Addendum

Submission to the Nunavut Water Board

Jericho Diamond Project

October 8, 2004

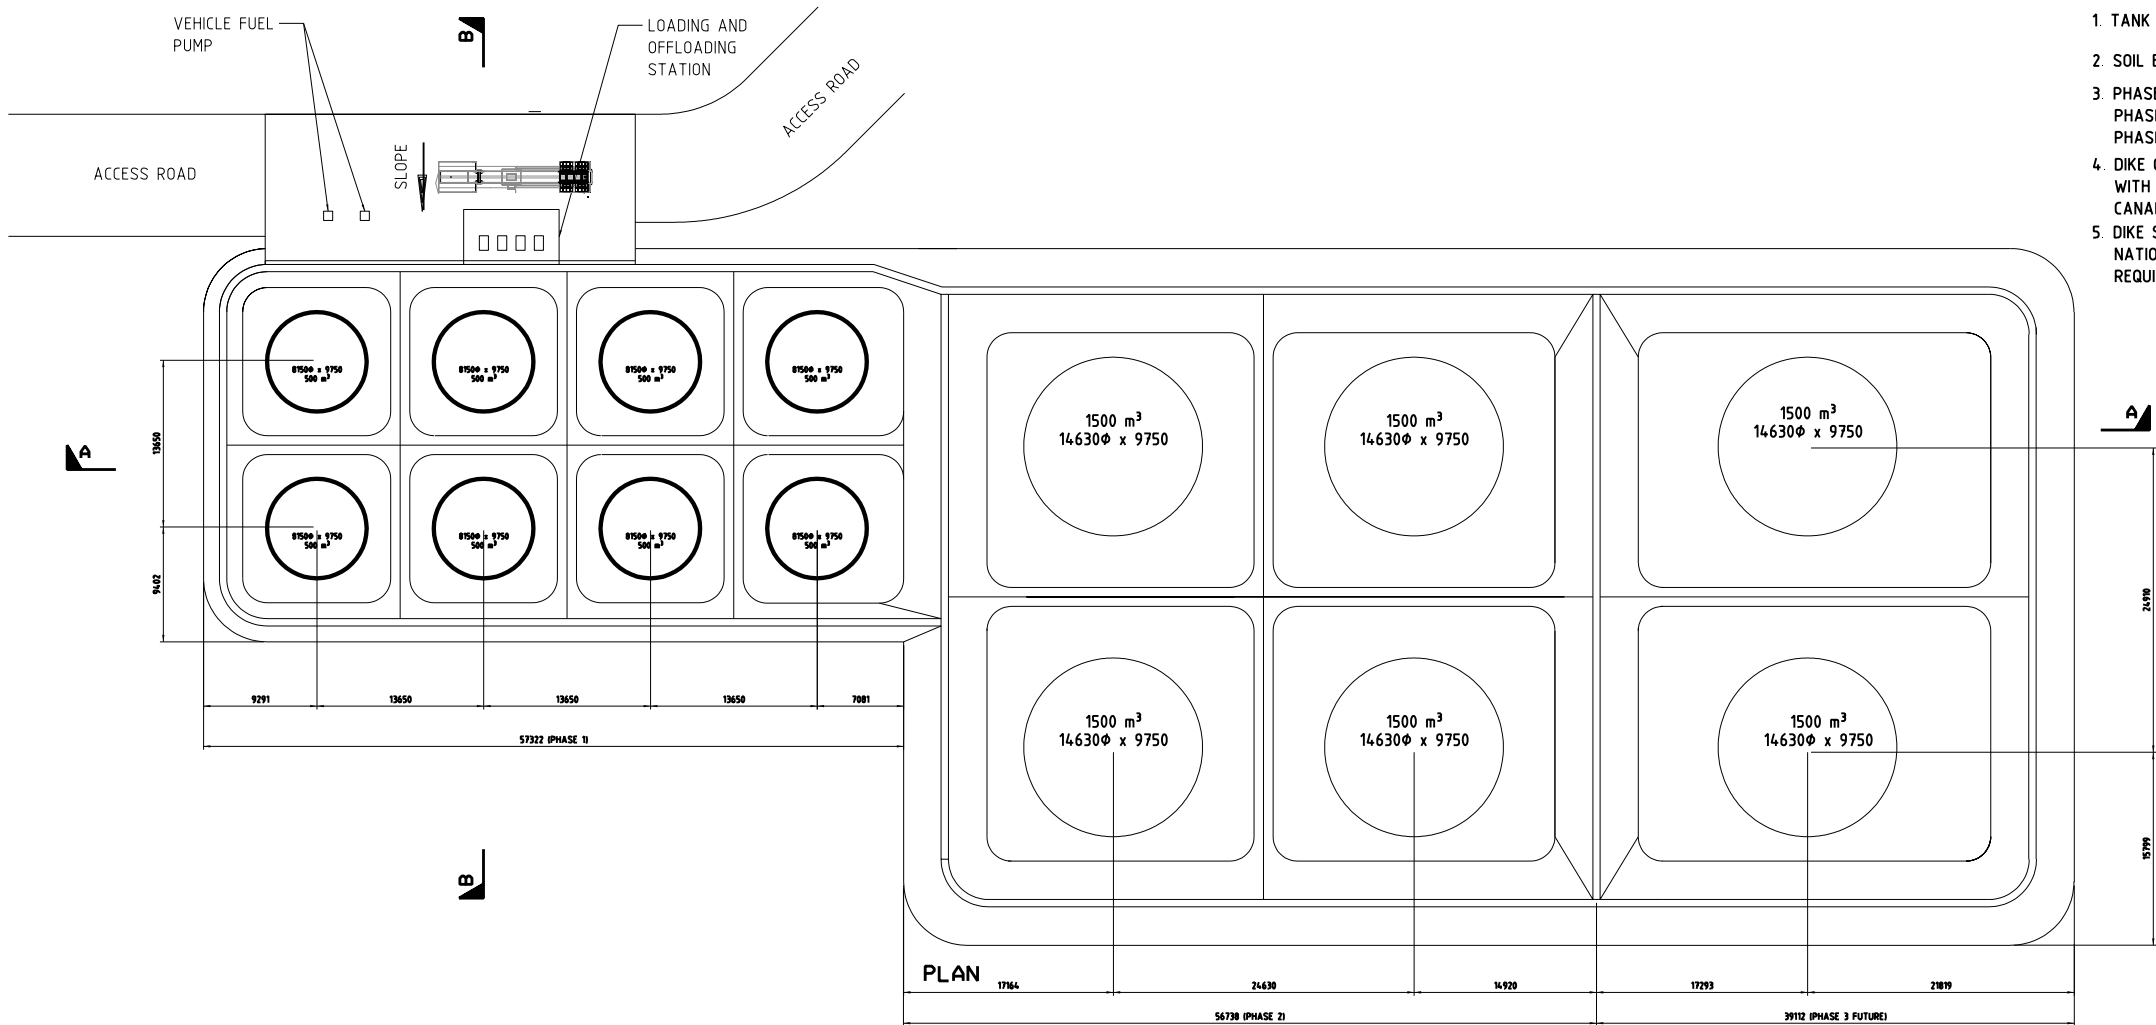
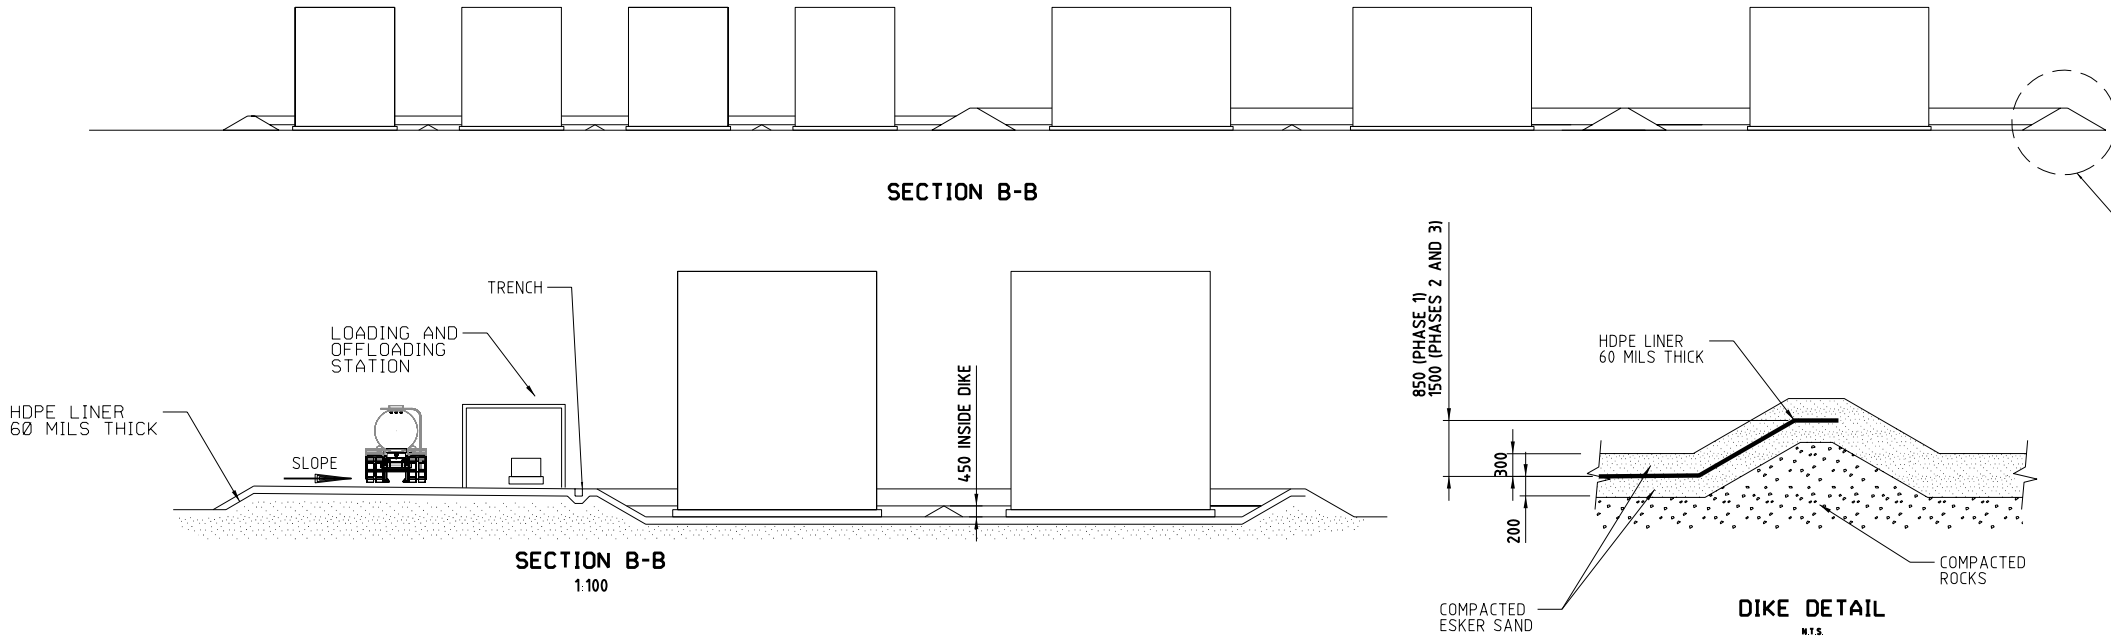
NWB Comment: Detailed Fuel Storage Plan not provided.

Response: Fuel Storage Plan attached for bulk fuel storage at the Jericho mine site.

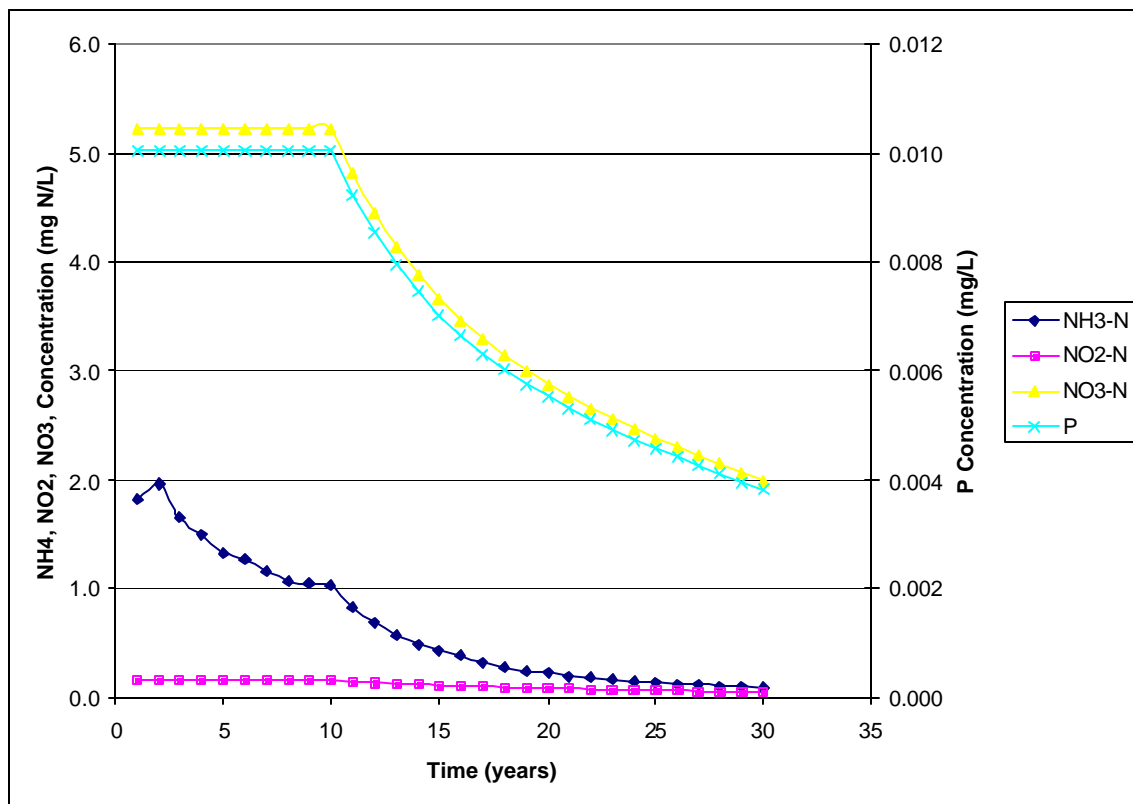
**4.1 (i)(iv)1.a. Open Pit Post Closure: Provide an estimate of the expected concentrations of ammonia and metals in the refilled mine pit, provide an estimate of degradation rates for these and any other constituents of concern, and indicate how long water quality in the pit water is likely to have concentrations above receiving water quality levels.** *NWB conformity review indicated that there were no estimates or discussion for metals or ammonia.*

The results of the calculations (see figure below), indicated that nutrient concentrations would remain relatively constant during the first 10 years of filling and then would decrease as clean inflows mix with the pit lake water. In the case of ammonia, the rate of decay would be somewhat faster due to uptake by algae. By the time the pit reaches its spill point at approximately year 20, nutrient concentrations are expected to be well below receiving water criteria.

DRAWING NUMBER	1CT004.06 - G12	REV
		A

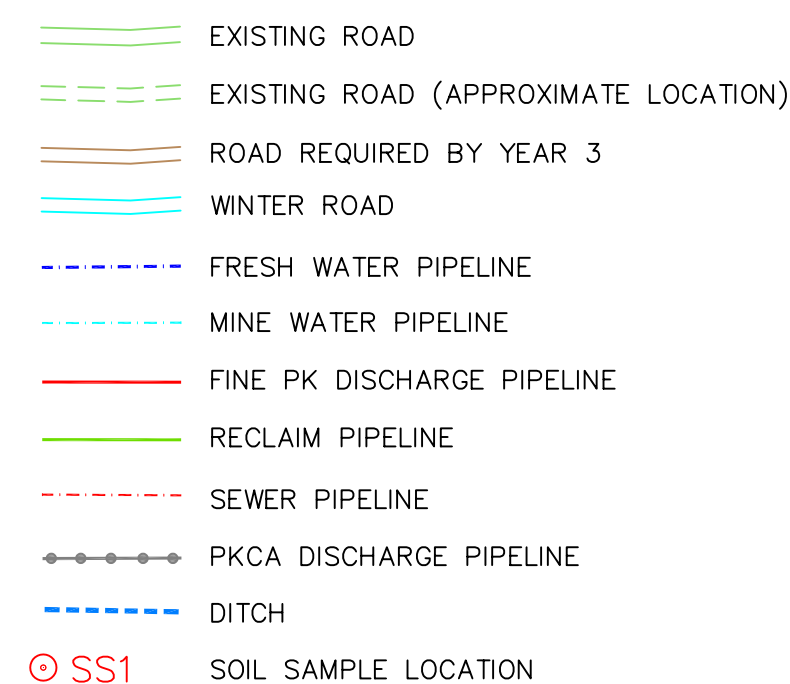
**NWB Comment:** re Air Quality Management Plan, no soils monitoring plan provided.

The attached drawing indicates 23 sites where sampling is suggested. The intent is for all areas where facilities will constructed be sampled prior to construction.
